Wayne Wright, W5XD
Directional Coupler

Rev 1.0
10/15/2023

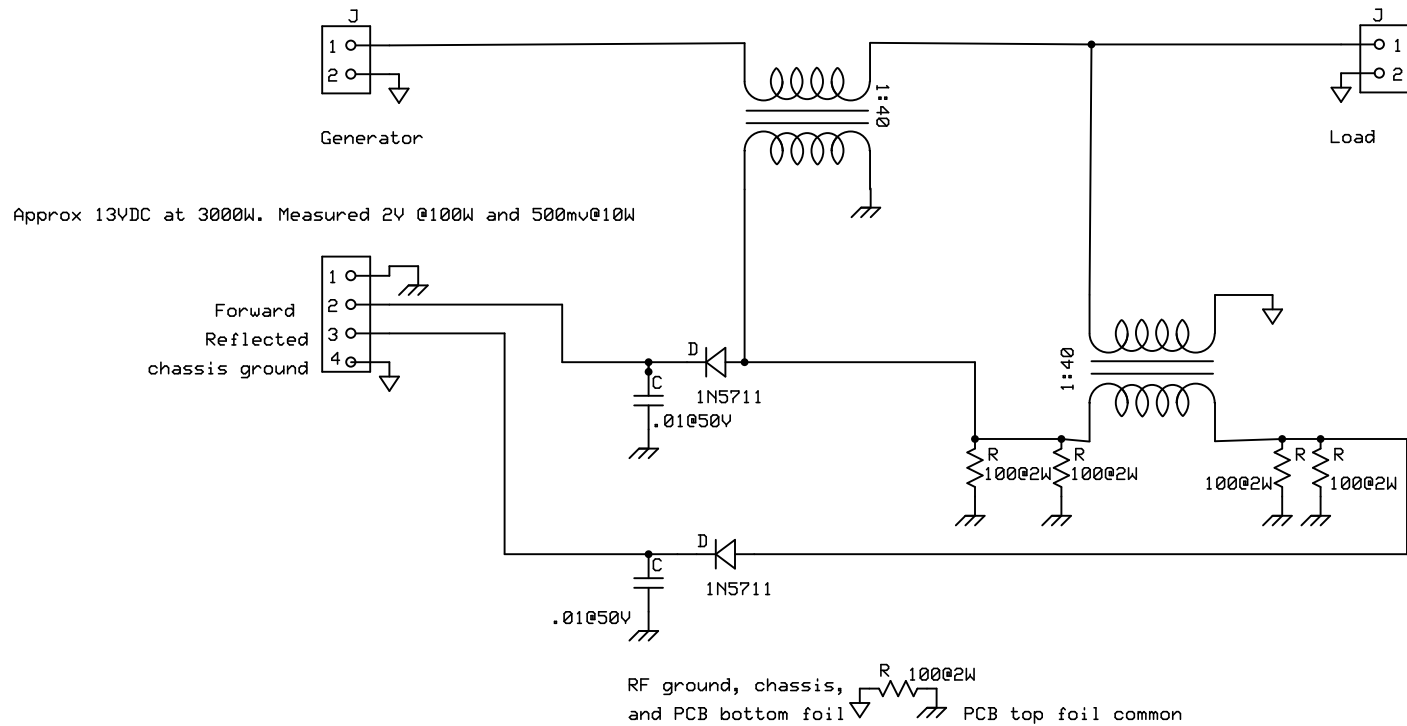
Exception: REV01 of the PCB has the 40T holes placed such that Forward and Reflected are reversed at the output

Fix this either by:

- a) reverse one of the transformer's wires to their opposite holes on the PCB OR
- b) wind the second transformer in the opposite direction when you construct it.
